Access Compliance Report

Public Rights-of-Way

(Curb Ramps)

Intersection ID: 46182	Main Street: SEVEN_OAKS_DR	Cross Street: GLOXINIA_RD	Location: W
ADA ID: 16F430EB6E24	Ramp Type: Perp	Initial Pass/Fail: Fail	Overall Compliance: No
Severity Score: 12.5			
Codes/Mitigation Info/Possible Solution		Field Measurements/Component Compliance

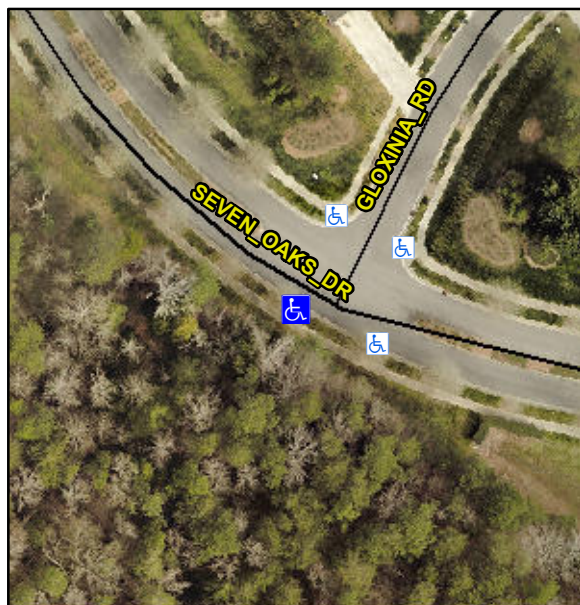
Not Found, R304.2.2

Compliance	Description	Data	Compliance	Description	Data
N/A	Ramp Length (in)	71.5	No	Ramp Slope (%)	9.1
Yes	Ramp Width (in)	48.0	Yes	Ramp XSlope (%)	0.5
N/A	Flare Type LT	N/A	N/A	Flare Type RT	N/A
N/A	Flare Slope LT (%)	N/A	N/A	Flare Slope RT (%)	N/A
N/A	Flare Traversable LT?	N/A	N/A	Flare Traversable RT?	N/A
N/A	Landing Length (in)	N/A	N/A	DWS Provided?	N/A
N/A	Landing Width (in)	N/A	N/A	DWS Contrast?	N/A
N/A	Landing Slope (%)	N/A	N/A	DWS Length (in)	N/A
N/A	Landing X Slope (%)	N/A	N/A	DWS Full Width?	N/A
N/A	Landing Curb? (Y/N)	N/A	N/A	DWS Offset (in)	N/A
N/A	Shared Landing?	N/A			
N/A	Gutter Ponding?	N/A	N/A	Gutter Slope (%)	N/A
N/A	Gutter Lip Ht (in)	N/A	N/A	Gutter X Slope (%)	N/A
N/A	Painted X Walk1?	No	N/A	Painted X Walk2?	N/A
	X Walk 1 Direction	To NE		X Walk 2 Direction	N/A
N/A	X Walk 1 Width (in)	N/A	N/A	X Walk 2 Width (in)	N/A
	X Walk 1 Slope (%)	3.2		X Walk 2 Slope (%)	N/A
	X Walk 1 X Slope (%)	1.1		X Walk 2 X Slope (%)	N/A

Remove & Replace Entire Ramp.
